5531 Midway  
Jefferson Commons  
Lot 8 Building Addition

Drainage and  
Grading Plan

### AREAS OF MODIFICATION BETWEEN APPROVED DRAINAGE GRADING PLAN AND ACTUAL AS-BUILT - JEFFERSON COMMONS - LOT 8 ADDITION

C-1  
Sheet 1 of 1

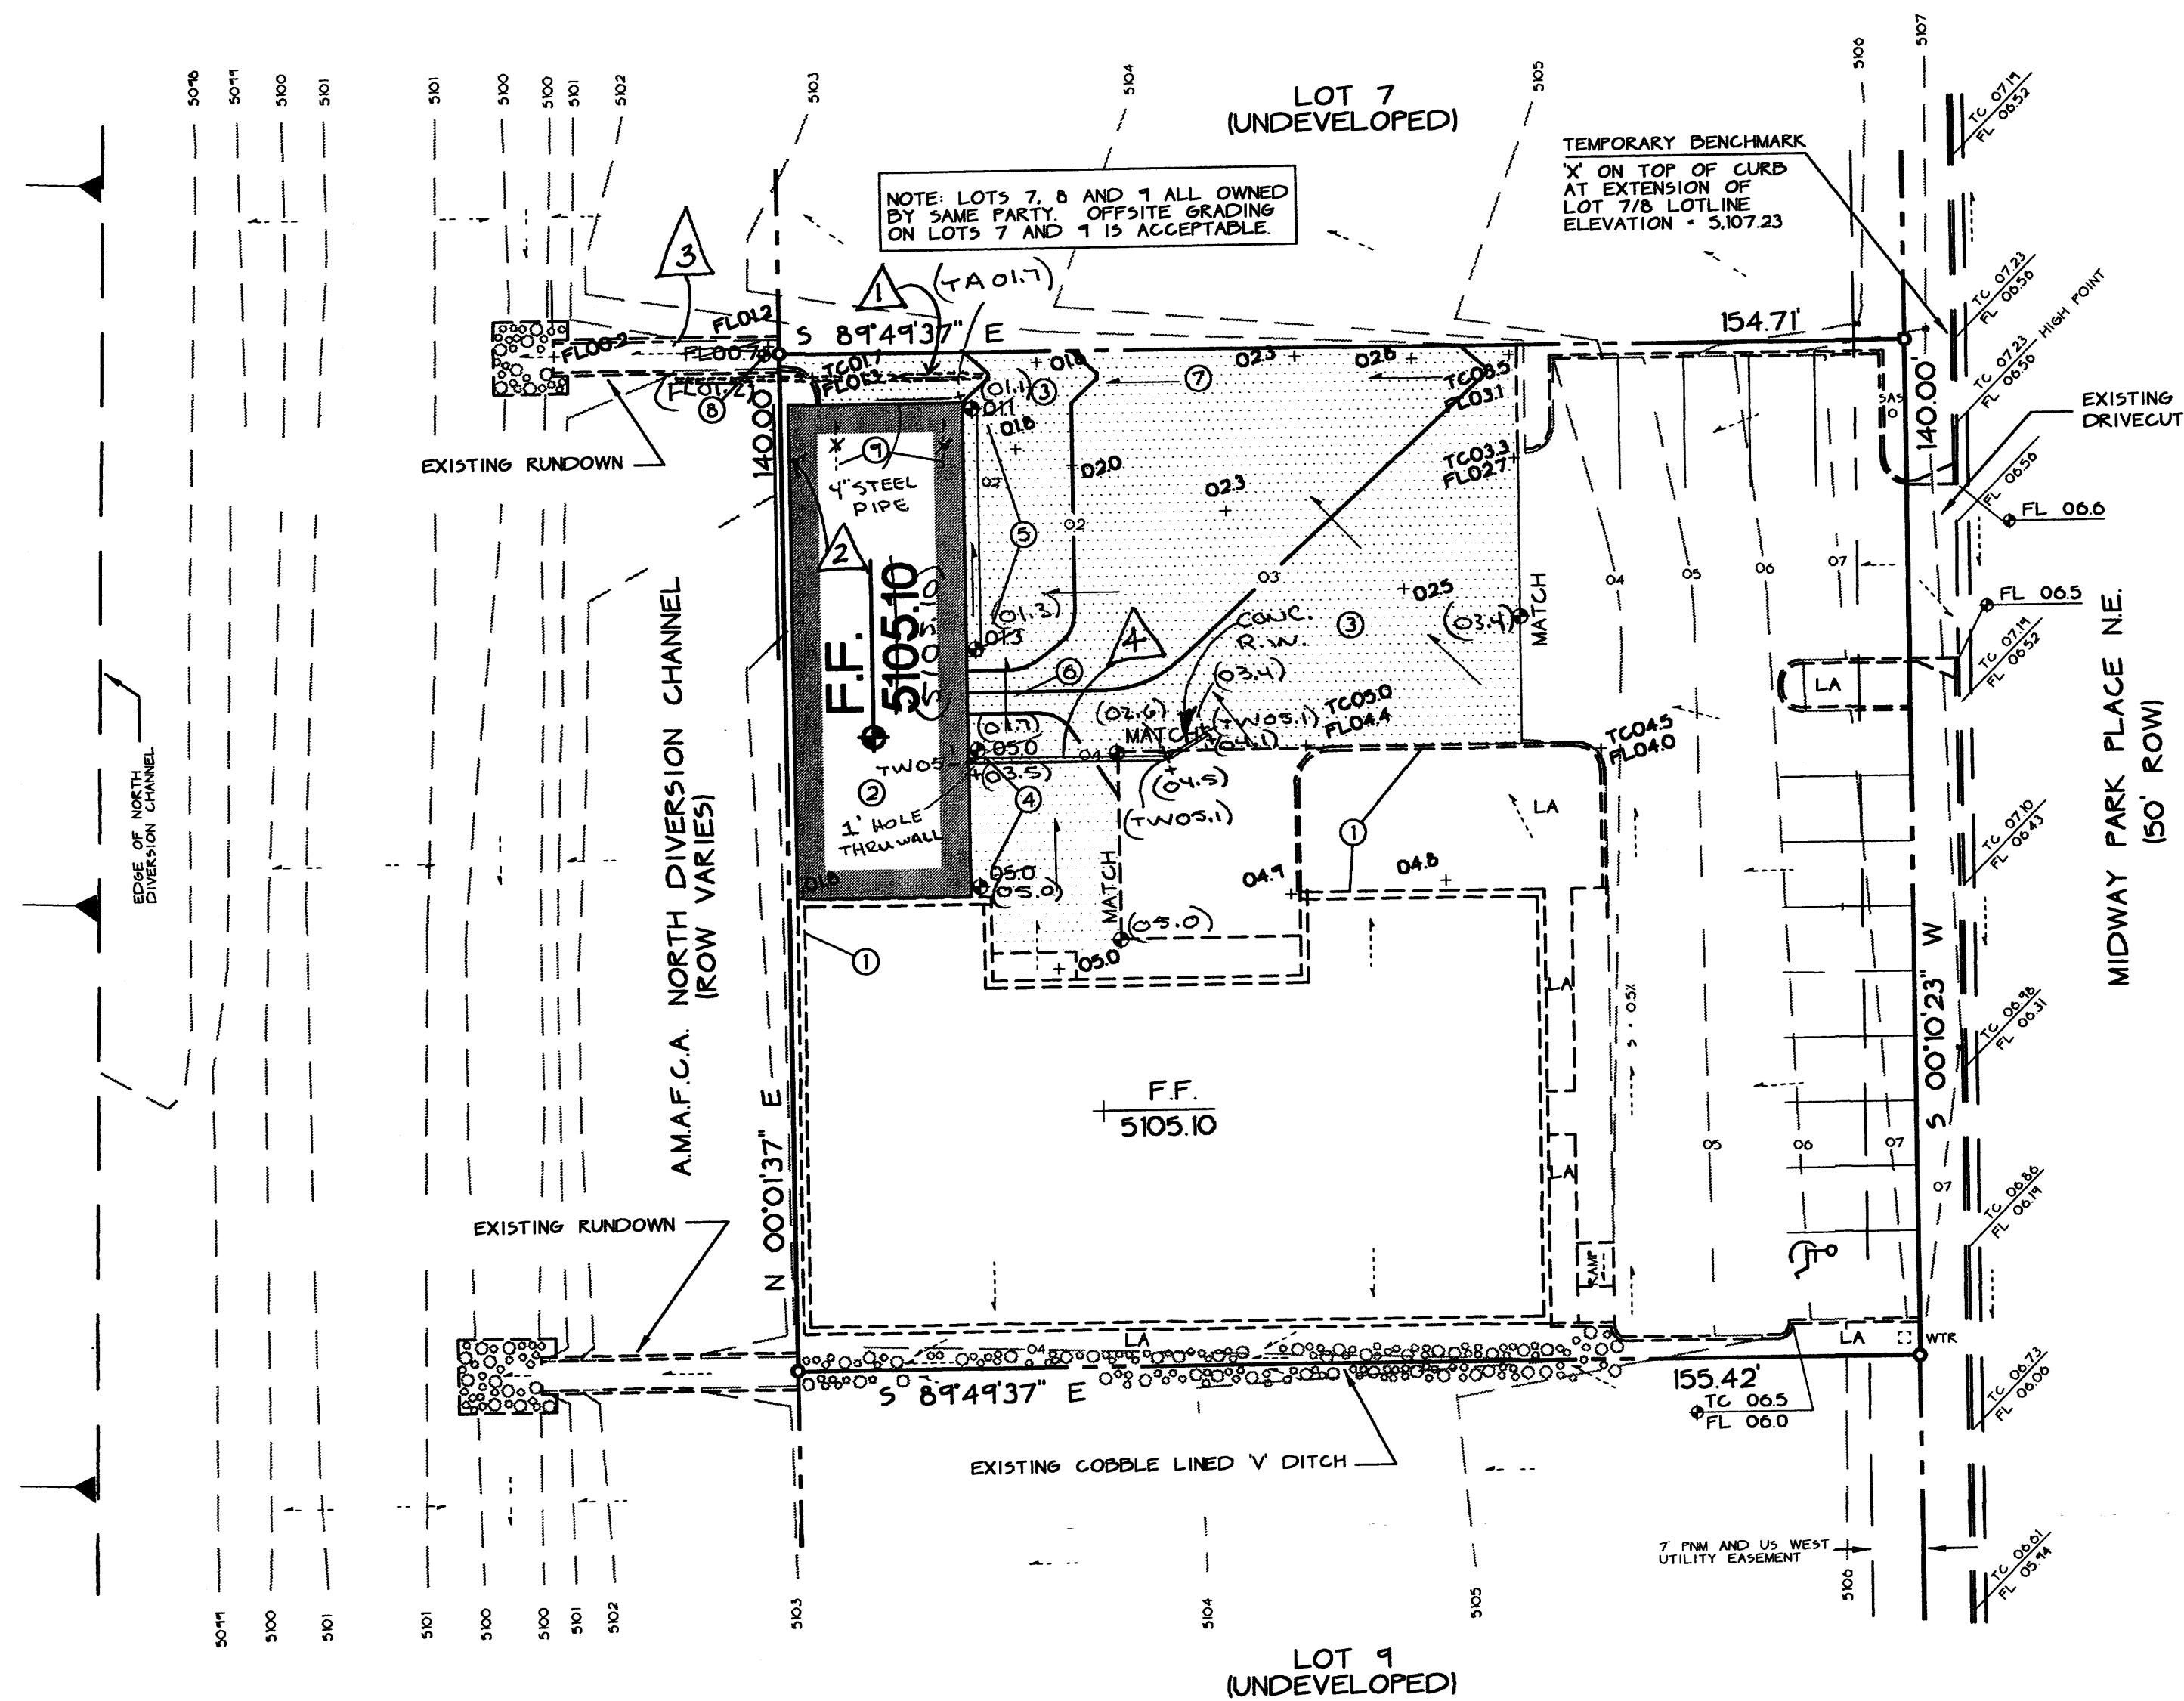
1. Shallow swale in asphalt to direct surface flow to AMAFCA rundown not constructed. 6" steel pipe installed at FL 01.1 to pass flows to AMAFCA North Diversion Channel. Note: If pipe ceases to function, flows will back up to elevation 01.7 (6" depth) before passing to north asphalt paved area to existing rundown.
2. Roof flow released to west side of building, captured within a PVC drainage system and released into the existing rundown. OKAY
3. Rundown not lowered (see note 1 above).
4. New concrete retaining wall constructed this area to achieve grade transition. OKAY

I, Christopher L. Weiss, P.E. hereby certify that the as-built information shown, is in substantial compliance with the approved drainage / grading plan with exceptions noted above.
